CITY OF IMPERIAL
IMPERIAL, CALIFORNIA

ADDENDUM NO. 2

TO THE PLANS AND SPECIFICATIONS FOR
LA BRUCHERIE LIFT STATION IMPROVEMENTS
BID NO. 2015-07

**LA BRUCHERIE LIFT STATION IMPROVEMENTS
GRADING & SITE PLAN**

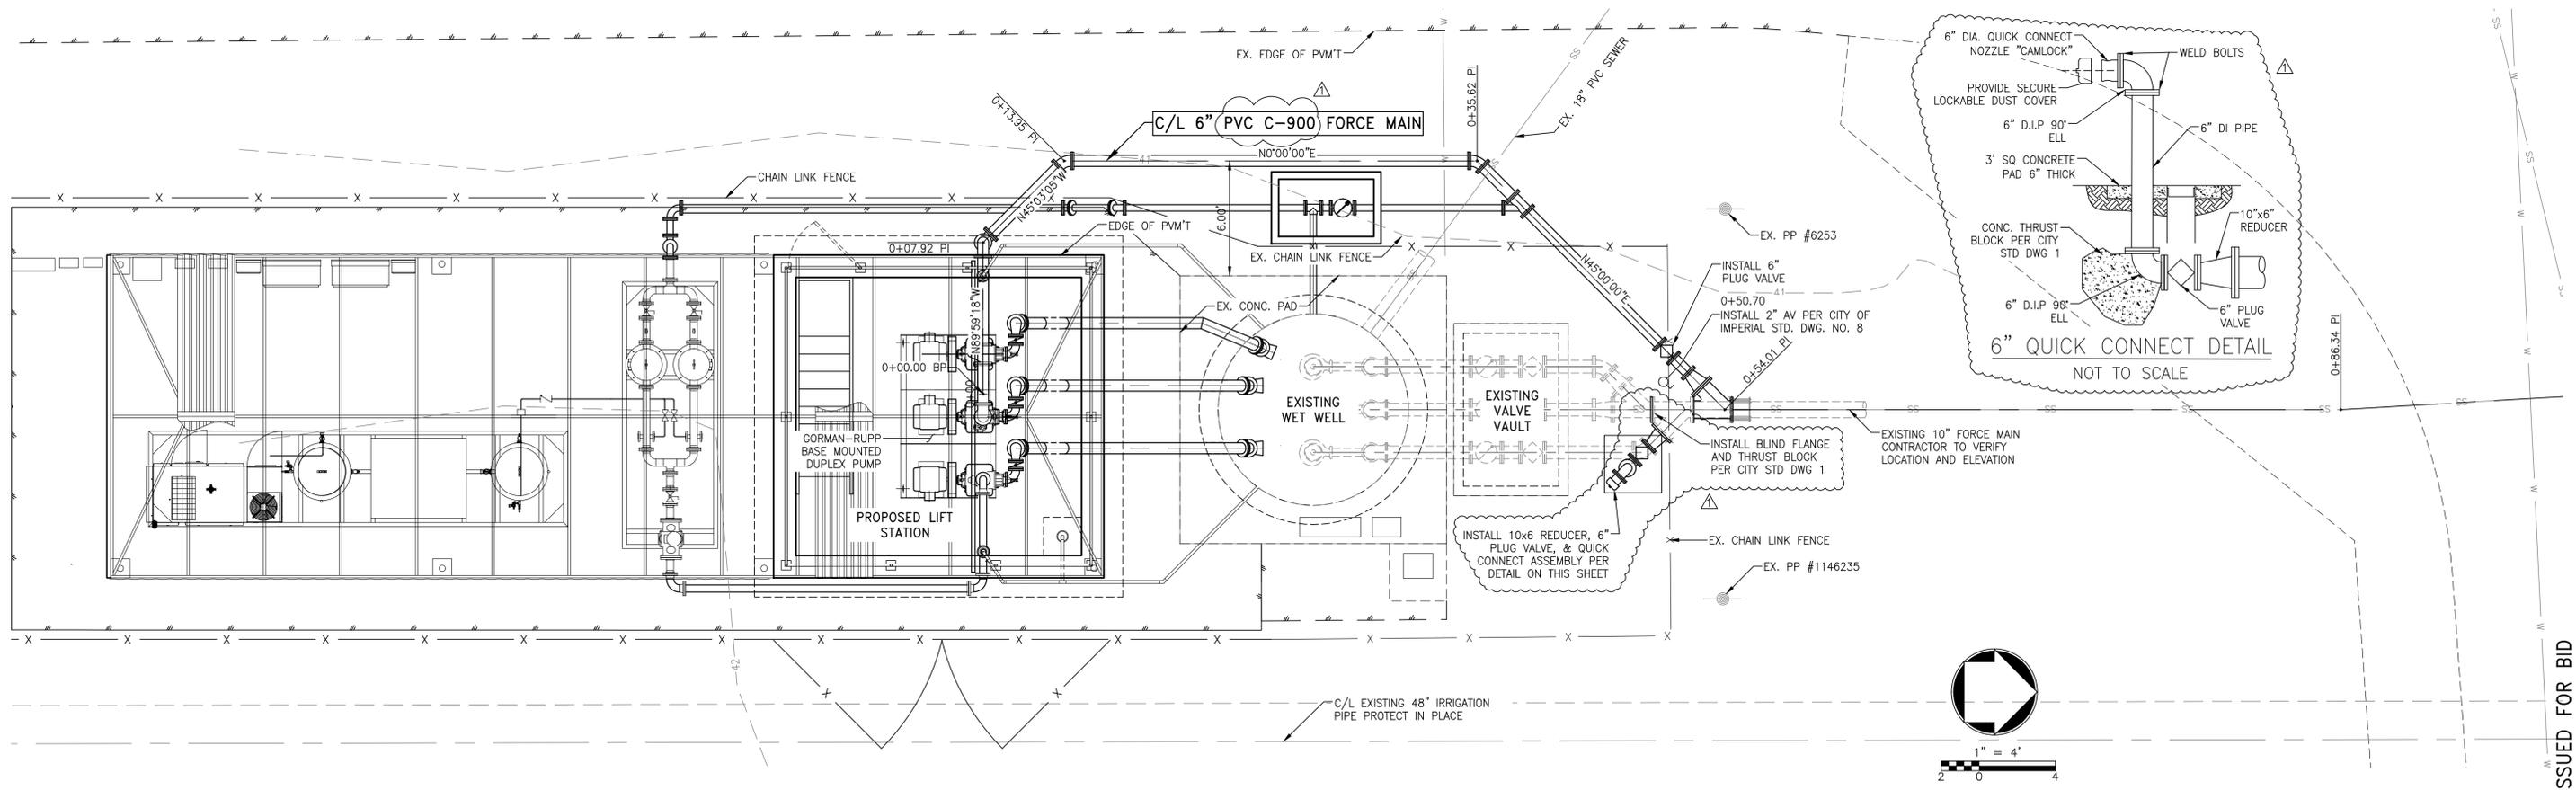
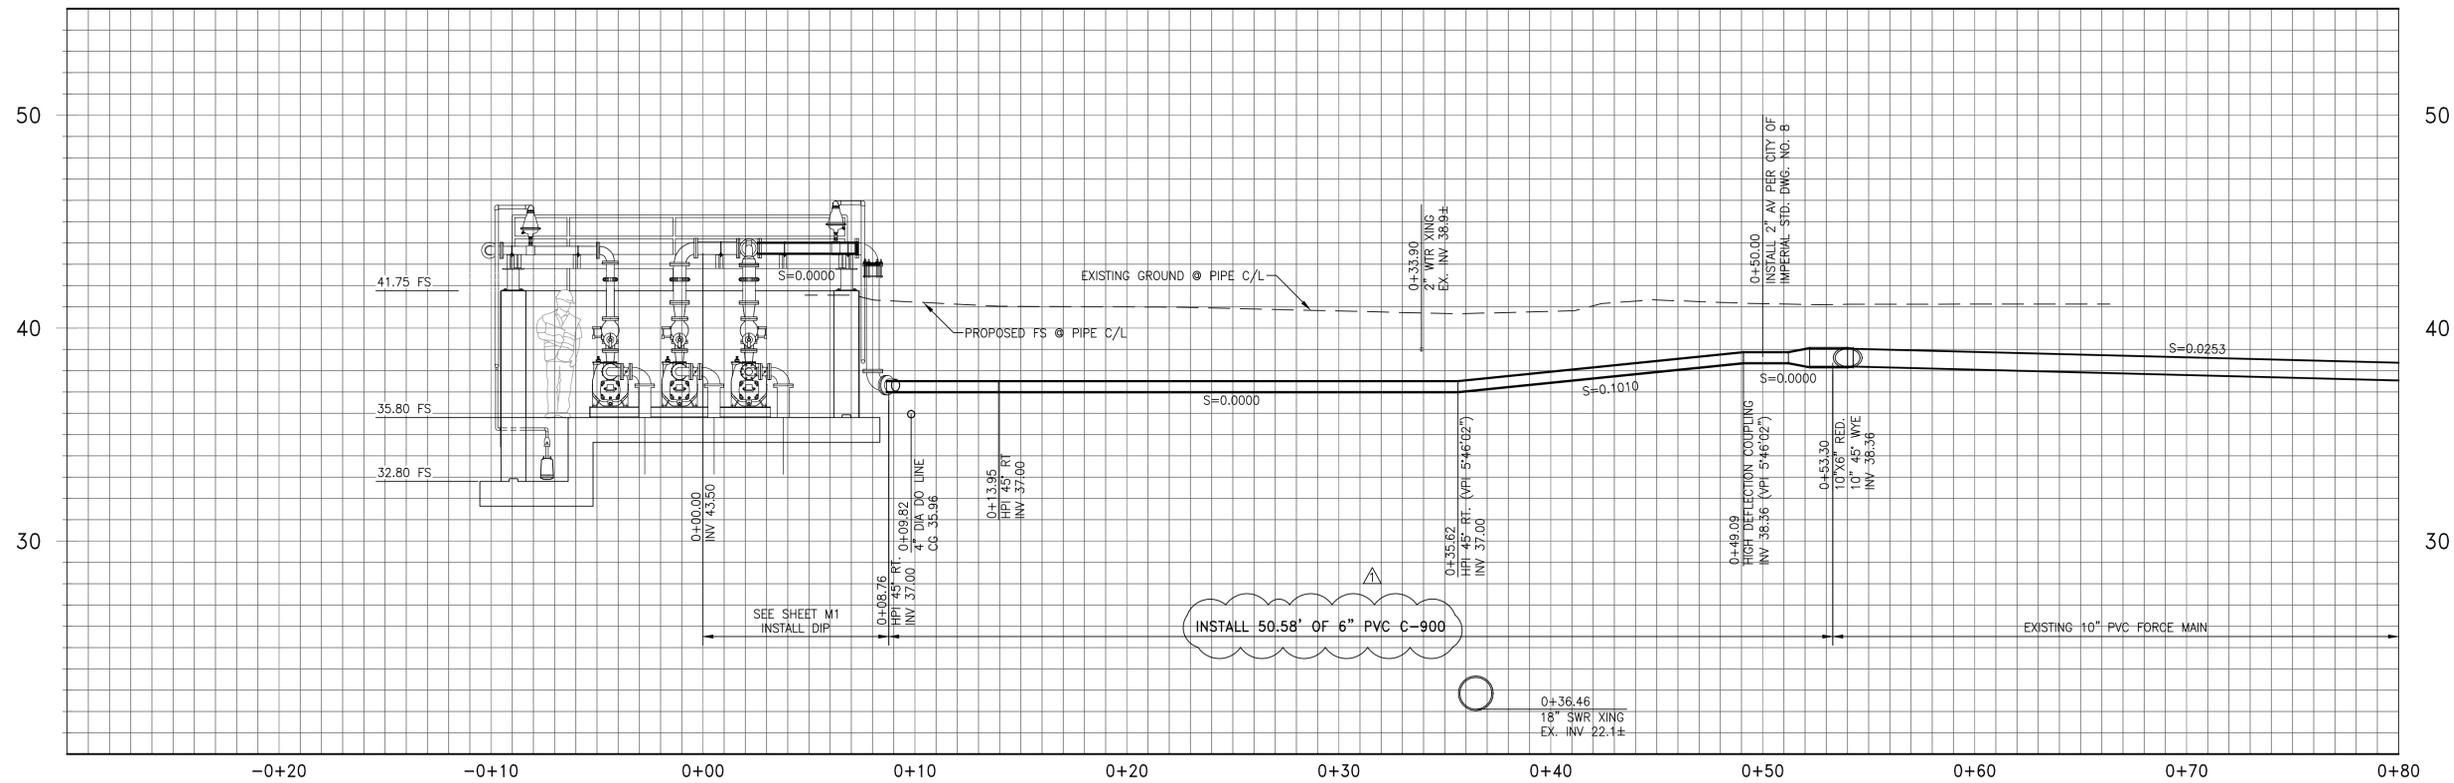
1. Sheet 4 (Attached) – Proposed fence dimensions have been extended to the south. Location of Electrical Panels has been revised. See Dwg. No. LE-1 for additional details.

REVISIONS				
NO.	DATE	INITIAL	DESCRIPTION	APPROVED/DATE
1	5/15	SB	MOVED ELEC. PANELS TO SOUTH END OF CANOPY MOVED FENCE FURTHER SOUTH	5/4/2015

LA BRUCHERIE LIFT STATION IMPROVEMENTS
FORCE MAIN PLAN & PROFILE

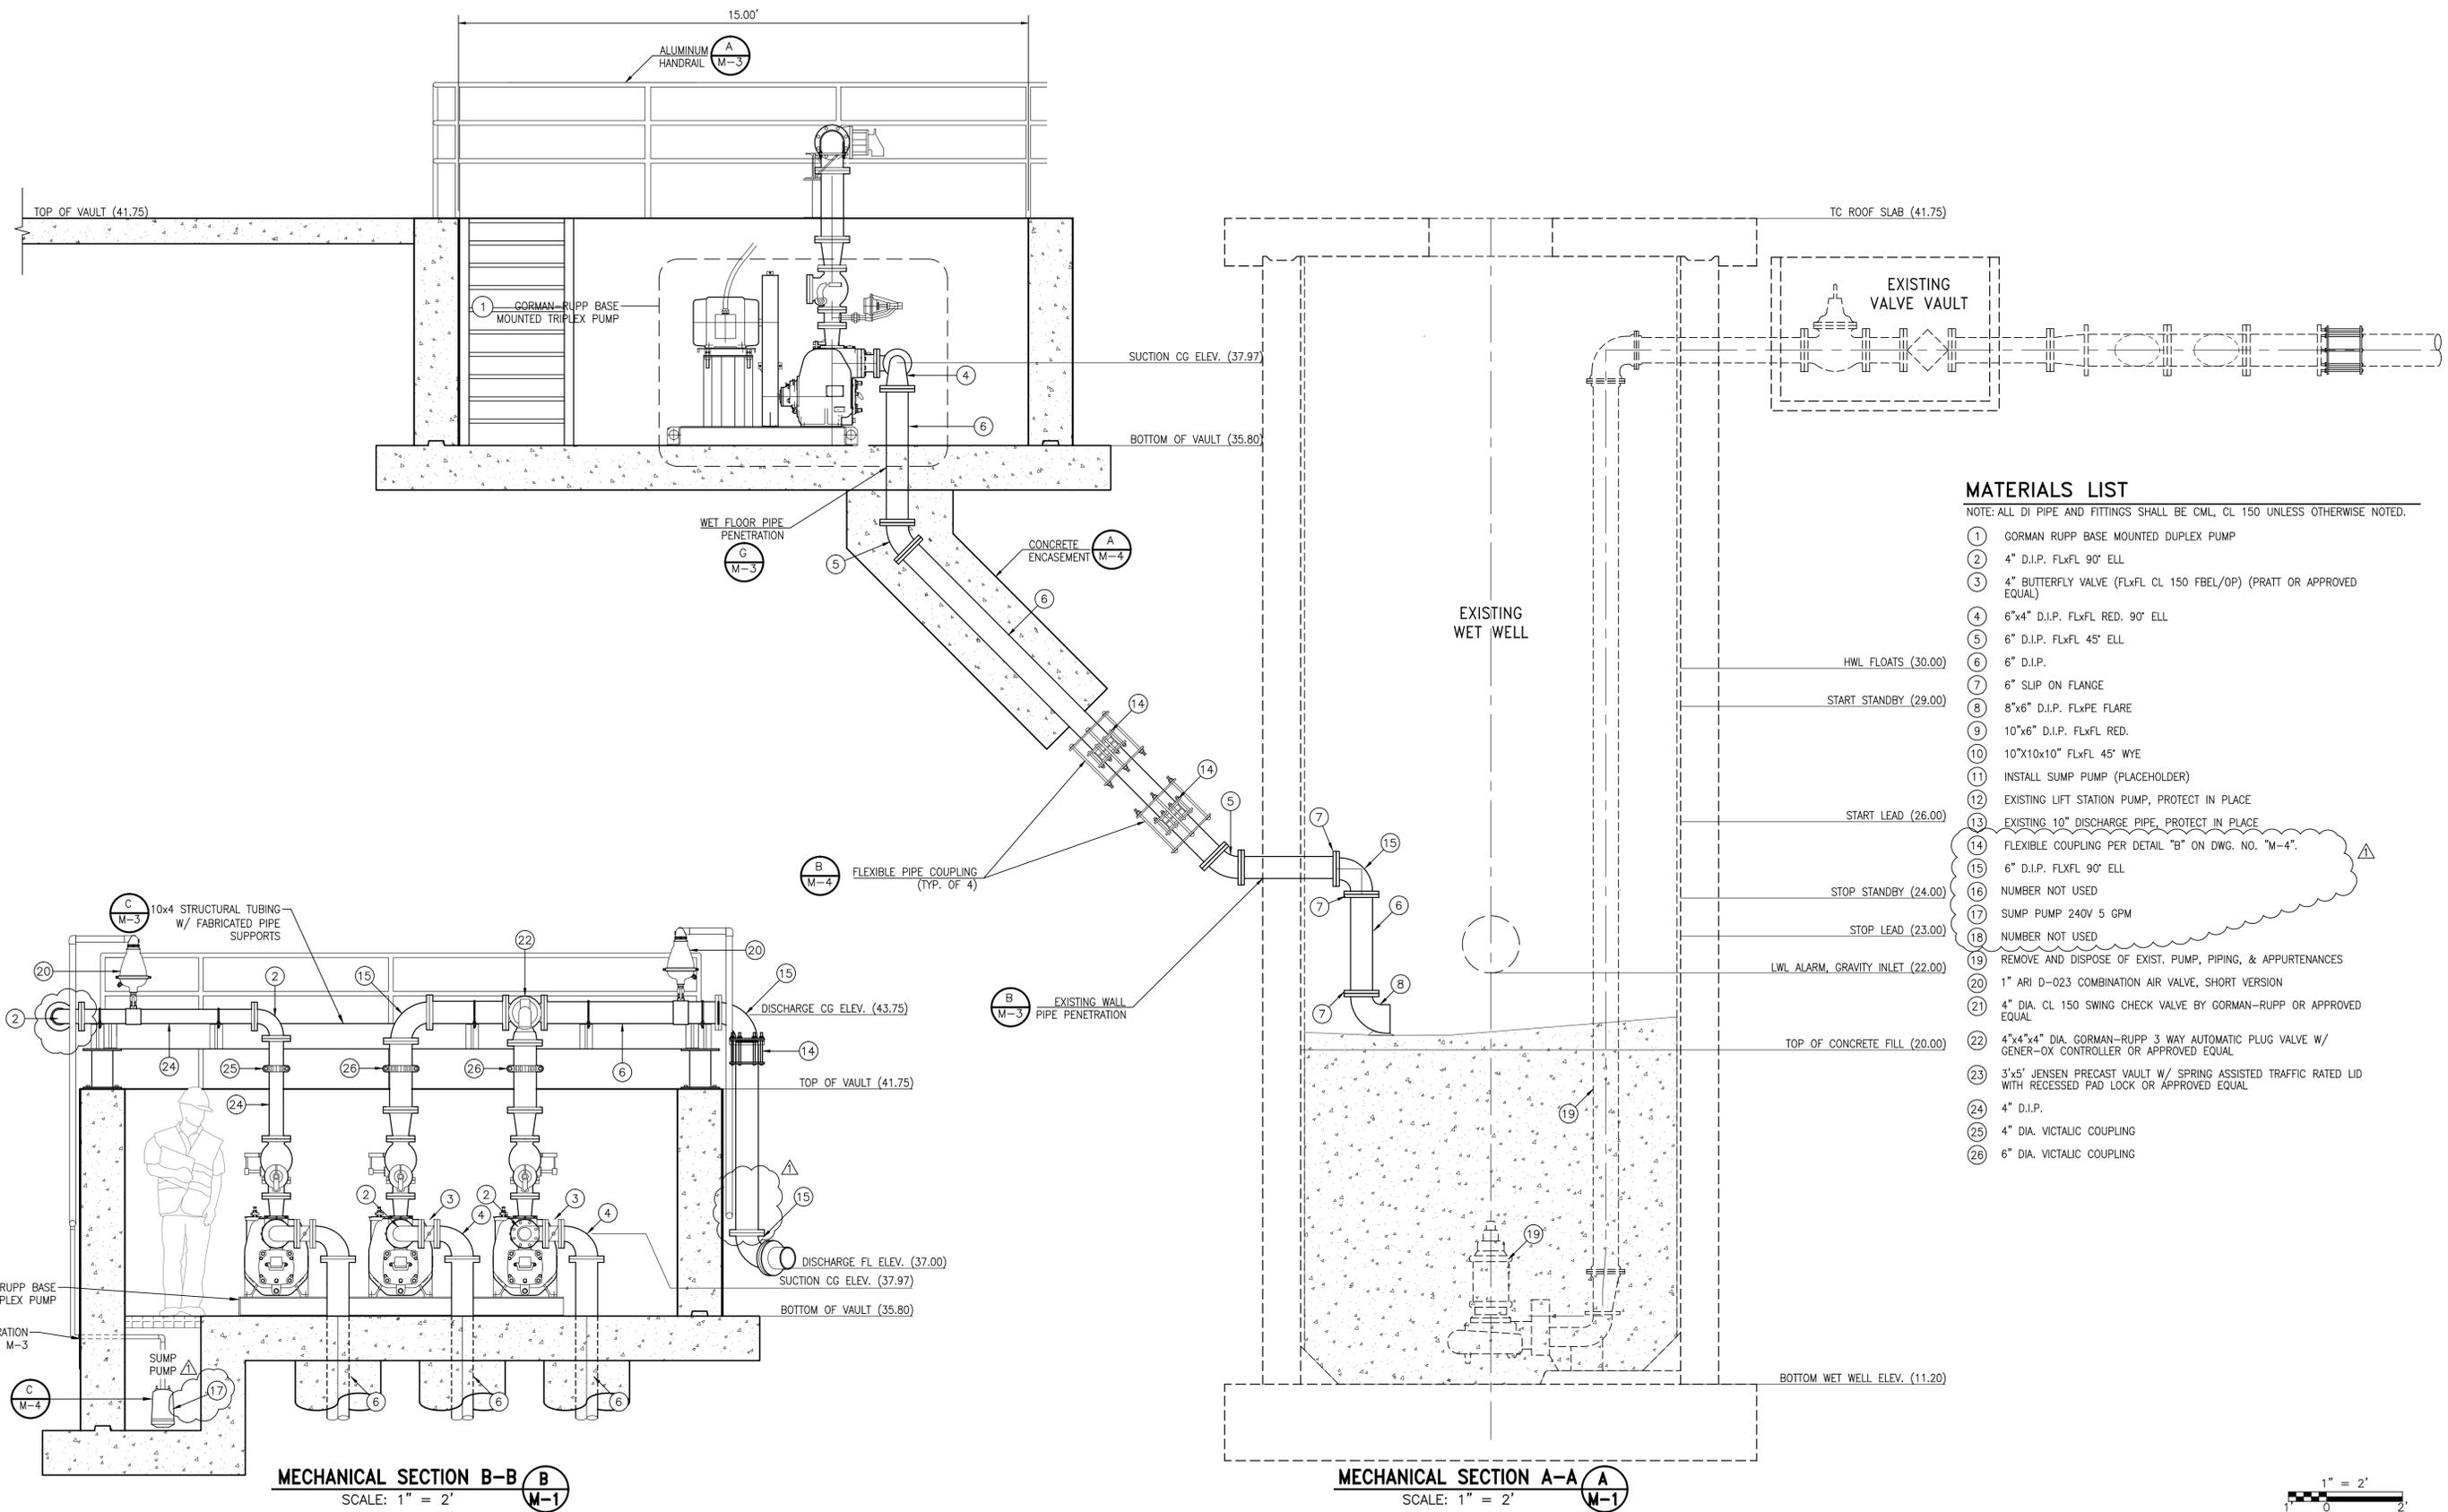
2. Sheet 6 (Attached and Sheet 7) – 6" Quick Connect Detail has been added. Proposed below grade force main material has been changed from ductile iron to PVC C-900.

REVISIONS				
NO.	DATE	INITIAL	DESCRIPTION	APPROVED/DATE
Δ	5/15	SLB	ADDED QUICK CONNECT ASSEMBLY & CHANGED DISCHARGE PIPING TO PVC	5/4/2015
